[Docket No. FAA-2017-0288; Product Identifier 2017-CE-007-AD; Amendment 39-19231; AD 2018-06-11]

Airworthiness Directives; Textron Aviation Inc. Airplanes

ACTION: Final rule.

Figure 1 to paragraphs (k)(1)(iii) and (v) of this AD: Cross section of v-band coupling

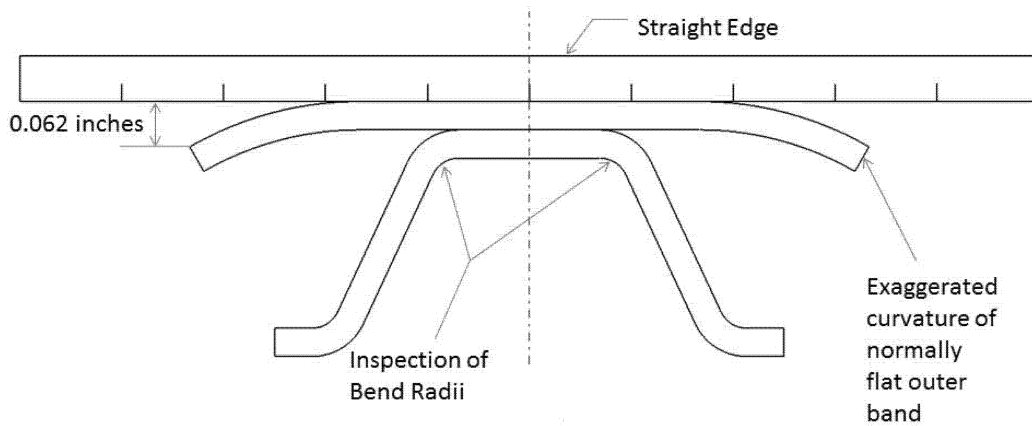
(iii) Visually inspect the flatness of the outer band using a straight edge. Lay the straight edge across the width of the outer band. The gap must be less than 0.062 inches. See figure 1 to paragraphs (k)(1)(iii) and (v) of this AD. If the gap exceeds 0.062 inches between the outer band and the straight edge, do not re-install the v-band coupling. Before further flight, you must install a new v-band coupling and restart the hours TIS for the repetitive replacement of the v-band coupling.

(v) Visually inspect the bend radii of the coupling v-retainer coupling segments for cracks. Inspect the radii throughout the length of the segment. See figure 1 to paragraphs (k)(1)(iii) and (v) of this AD. If any cracks are found, do not re-install the v-band coupling. Before further flight, you must install a new v-band coupling and restart the hours TIS for the repetitive replacement of the v-band coupling.
